UNITED STATES PATENT AND TRADEMARK OFFICE

APPLICATION NO.	FILING DATE	FIRST NAMED INVENTOR	ATTORNEY DOCKET NO.	CONFIRMATION NO.
10/811,464	03/26/2004	Richard Hai Huang	SAR100064000	1785
22891	7590	07/27/2005	EXAMINER	
DELIO & PETERSON 121 WHITNEY AVENUE NEW HAVEN, CT 06510			LUGO, CARLOS	
			ART UNIT	PAPER NUMBER
			3676

Office Action Summary

DETAILED ACTION

FIG.3

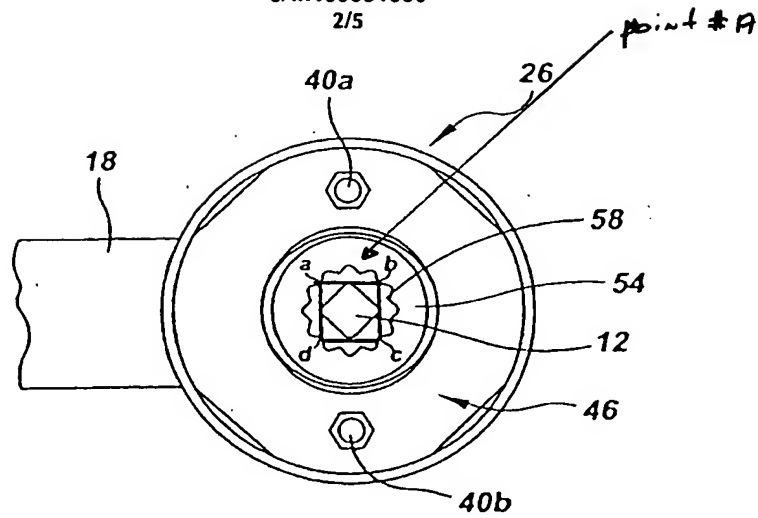
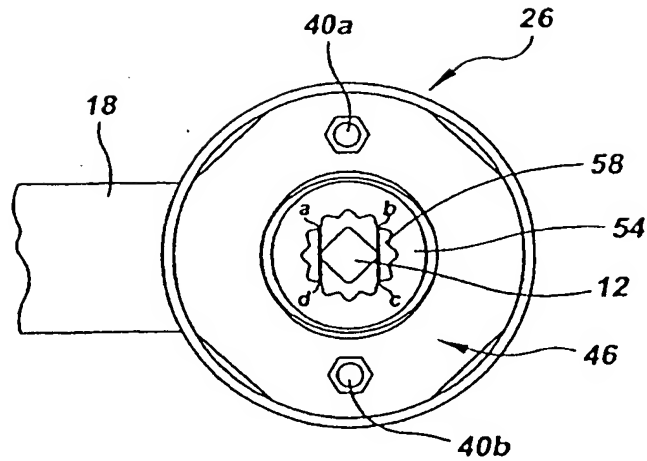
1. The drawings are objected to because:
 - In Figure 2, change "10" to -18-.
 - In Figure 3, clearly illustrates the spindle 12 (see attachment #1 point A).

FIG.4

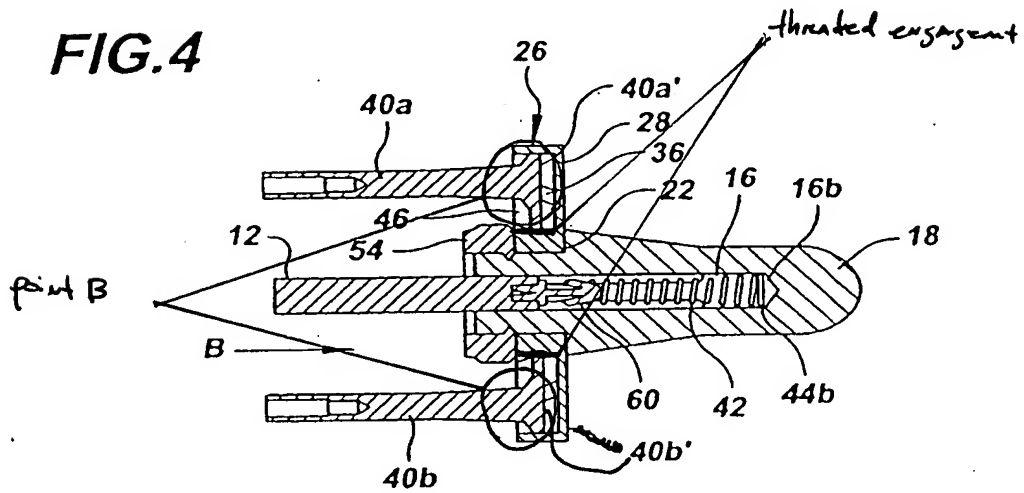
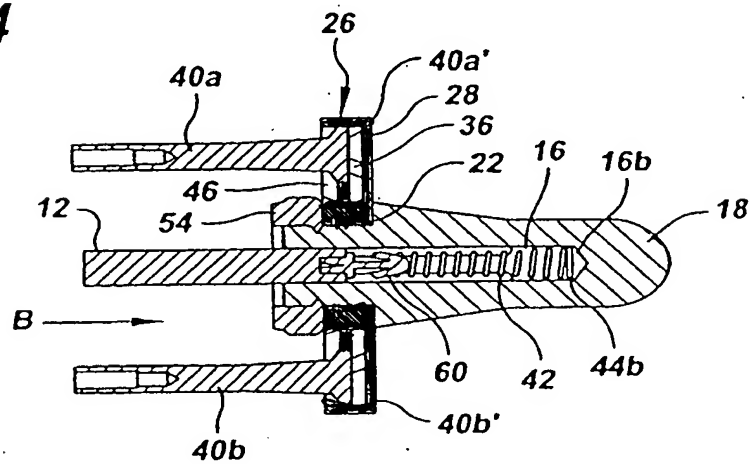
- In Figures 4 and 5, clearly define the mounting plate and the mounting posts with appropriate cross-hatching. The current drawings show that the mounting posts and the mounting plate are a one-piece embodiment when they are separate members connected together (see attachment #1 point B).

- In Figure 4, change the pointing line position of element 40b' (see attachment #1).
 - In Figure 5, change the pointing line position of element 48' (see attachment #1).

As seen in Figure 4, see attachment #2, the cover 26 has a lip 34 and the mounting plate 46 also has a lip 48. The lip 48 is located over the lip 34; therefore, the cover lip 34 has external threads that threadedly engage inner threads at the mounting lip 48.
